**AGUIRRE OFFSHORE GASPORT PROJECT
FINAL ENVIRONMENTAL IMPACT STATEMENT**

Responses to Comments on the Draft Environmental Impact Statement

Review Comments
Aguirre Offshore GasPort Project, Draft EIS

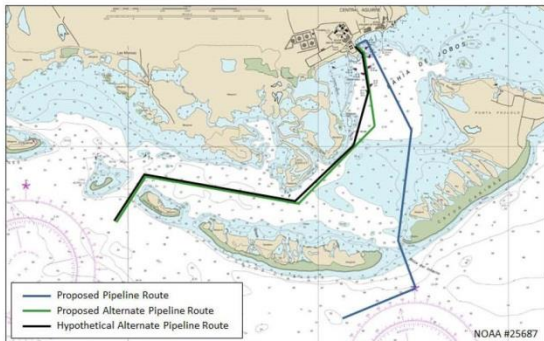
- The proposed alternate pipeline routes only follow an approximated corridor representing the barge channel (Draft EIS, p. 3-12, Fig. 3.4-1 & p. 3-17, Fig. 3.5-1), whereas recent acoustic surveys by NOAA (NOAA Technical Memorandum NOS NCCOS 133, Whitall et al. 2011) provide detailed bathymetric information that can be used in conjunction with NOAA chart #25687 (Bahia de Jobos and Bahia de Rincon) to better define the location and water depths of the barge channel. For example, note that a hypothetical alternate pipeline route can be designed to explicitly follow the barge channel as measured in the NOAA acoustic survey (Fig. 3).

Figure 4. Environmentally sensitive resources impacted by project alternatives, Aguirre Offshore GasPort Project (Draft EIS, p. 3-24, Fig. 3.5-2).

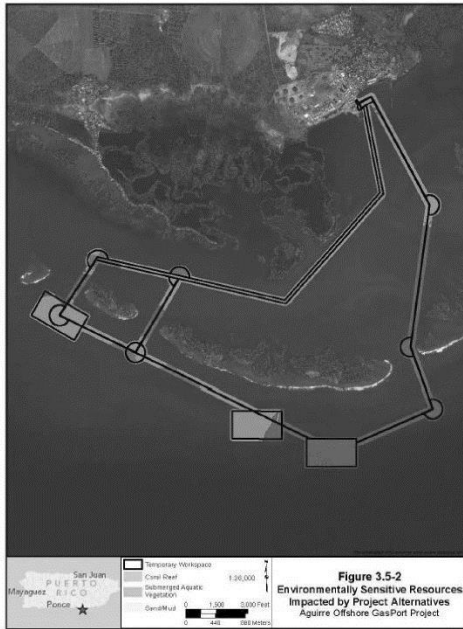
CO03-03 • The biological assessments described in the Draft EIS and associated Tetra Tech reports provide detailed surveys of ESA species located along the proposed pipeline route, as well as indications of environmentally sensitive resources impacted by alternative routes (Fig. 4); however, not included in the biological assessments are data on nearby adjoining areas that could be utilized to optimize the pipeline route for minimizing impacts to environmentally sensitive areas. Accordingly, biological assessments should be extended to explore these possibilities. [Note: Data from the recent habitat survey conducted in Jobos Bay by NOAA (NOAA Technical Memorandum NOS NCCOS 133, Whitall et al. 2011) should provide additional habitat and species data necessary for this assessment.]

CO03-03 Most agencies request relevant surveys of resources along a proposed route to aid in the decision of approval of the Project. If an alternative is determined to be preferable, additional survey work may be required. We would point out that we requested additional benthic surveys along the pipeline alternatives discussed in the EIS. Further, we refined one of the pipeline alternatives (Alternative Route 6) to further minimize impacts on coral resources. We are recommending that, if use of an HDD is found to likely be unsuccessful, Aguirre LLC use Alternative Route 6 to substantially reduce impacts on coral resources.

Figure 5. Hypothetical alternate pipeline route following bare channel and minimizing overlap with reef structures, superimposed on Detailed Structure Map developed by NOAA for Jobos Bay (NOAA Technical Memorandum NOS NCCOS 133, Whitall et al. 2011, p. 43, Fig. 2.47).

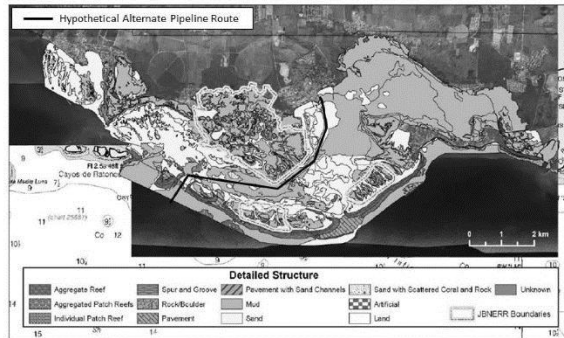
CO03-04 There is discussion in the Draft EIS of building the offshore terminal to withstand significant storm events, such as hurricanes, but limited indication of similar storm readiness considerations for the subsea pipeline. With the relatively shallow depth of the Boca del Infierno pass, the potential occurrence of sizeable storm events in this region, and given the direct lay method of installation, the proposed pipeline route through the pass would be susceptible to significant wave forces and stress. These potential wave conditions should be considered with regard to both route selection and the pipeline installation method.

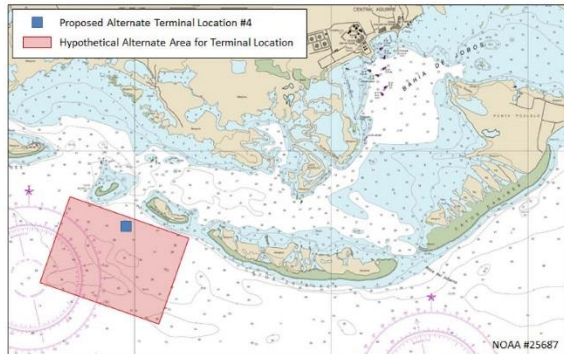
CO03-05 (cont'd) • Given the presence of environmentally sensitive resources in the habitat areas offshore of Jobs Bay, which include federally listed threatened or endangered species, there is a need to fully explore options that minimize impacts to the benthic environment during terminal installation and operation. Using the stated criteria for locating the terminal (Draft EIS, p. 3-10) "reasonably close to the Aguirre Plant", "located in sufficient water depths to accommodate the offshore terminal design", "avoids sensitive marine resources", "avoids population centers that could potentially create increased impacts on recreational users, safety concerns, and visual impacts" and "has a stable seafloor with favorable wind and wave data", the selection of terminal location is a function of overlapping feasible areas (i.e. maps) representing each of the individual criterion in order to identify areas where the criteria intersect. This is a common analysis technique in the field of Geographic Information Systems (GIS), where spatial maps and location-specific data are analyzed to derive spatial relationships. For example, using NOAA nautical chart #25687 (Bahía de Jobs and Bahía de Rincon) as a basemap, a preliminary analysis can be used to identify offshore areas near alternative site #4 that are a reasonable distance from the Aguirre Plant and are located in 50-60 ft water depth (Fig. 9). Such an analysis could be expanded to eliminate areas within close proximity to the nearby keys (i.e. only select areas that are further offshore), and thus minimize impacts to recreational resources (which are currently identified as significant limitations against selecting alternative terminal sites #3 and #4, but that could be potentially resolved by moving alternative terminal site #4 further offshore). Such an analysis would narrow the extent of areas that need to be surveyed with respect to identifying impacts to benthic habitats, and the resulting survey could be utilized to optimize terminal location such that impacts to benthic resources are minimized.
